DESIGN/PROCESS CHANGE NOTIFICATION

FAN6921A MLMY	FAN6921A MRMY	FAN6921 MLMY
FAN6921 MRMY

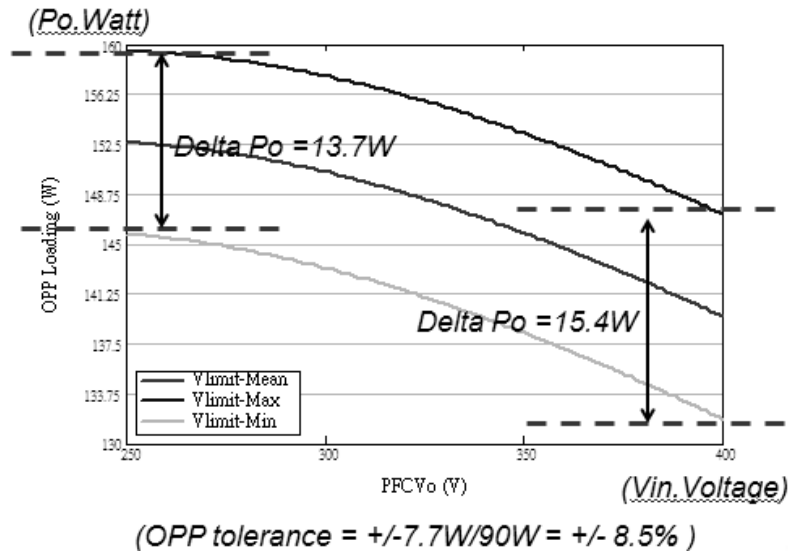
Datasheet electrical values of $I_{DET}=550\mu A$ of 0.37 V (minimum) and 0.43 V (maximum).

Datasheet electrical values of $I_{DET}=550\mu A$ of 0.34 V (minimum) and 0.46 V (maximum).

To better align listed datasheet limits with the actual product performance based on design and manufacturing tolerances.

Based on power boards with 90W adapters:

R_{sense} : 0.160 Ω , L_m : 480 μ H, N_p =32, N_s =6, N_{aux} =6, R_{det} =180k, T_{off_delay} =400ns

Before change: V_{limit} tolerance = ± 30 mV, I_{det} =260 μ A~417 μ A from V_{in} =250V~400V

Based on power boards with 90W adapters:

R_{sense} : 0.160 Ω , L_m : 480 μ H, N_p =32, N_s =6, N_{aux} =6, R_{det} =135k, T_{off_delay} =400ns

After change: V_{limit} tolerance = ± 60 mV, I_{det} =347 μ A~556 μ A from V_{in} =250V~400V
